Application No.: 10/047,758

Docket No.: JCLA7847

REMARKS**Present Status of the Application**

FIG. 1 (PRIOR ART)

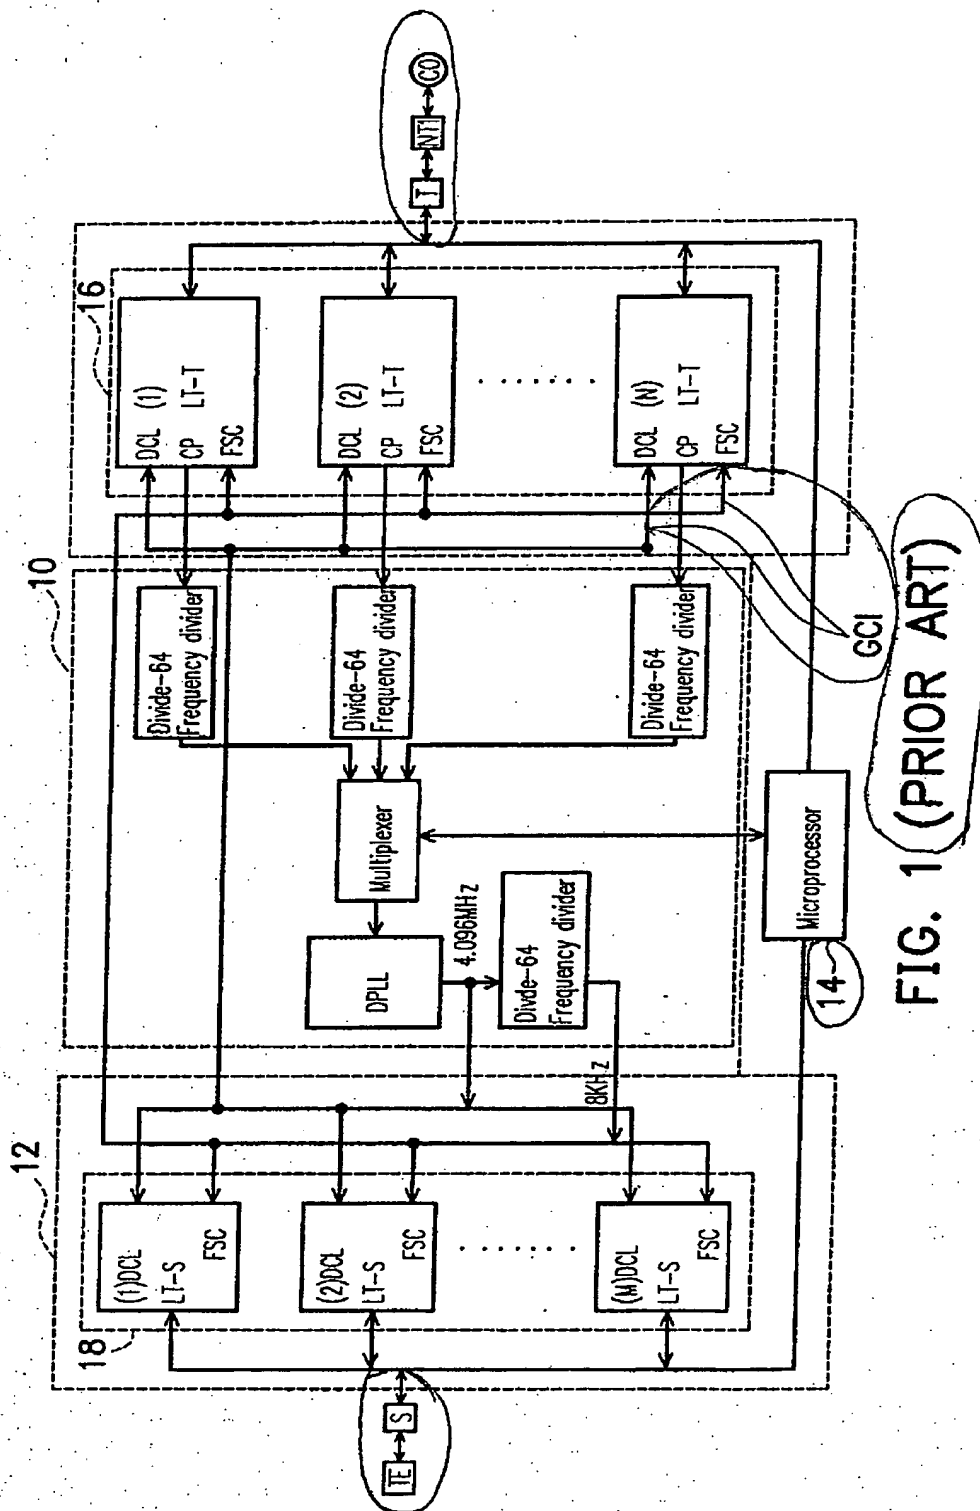
With respect to Fig.1 and fig.2, the drawings fail to show network terminal (NT1), trunk (T), central office (CO), terminal equipment (TE), subscribe interface(S), generic circuit interface (GCI). With respect to Fig.4, some items need to be corrected.

In response thereto, Fig.1 and 2 are so amended to be added block symbols including network terminal (NT1), trunk (T), central office (CO), terminal equipment (TE), subscribe interface(S), generic circuit interface (GCI). Moreover, the Fig.1 is amended with a legend "Prior Art." Blocks with reference numerals 420, 422, 416 and 418, as shown in Fig.4, are also amended as instructed by the Examiner.
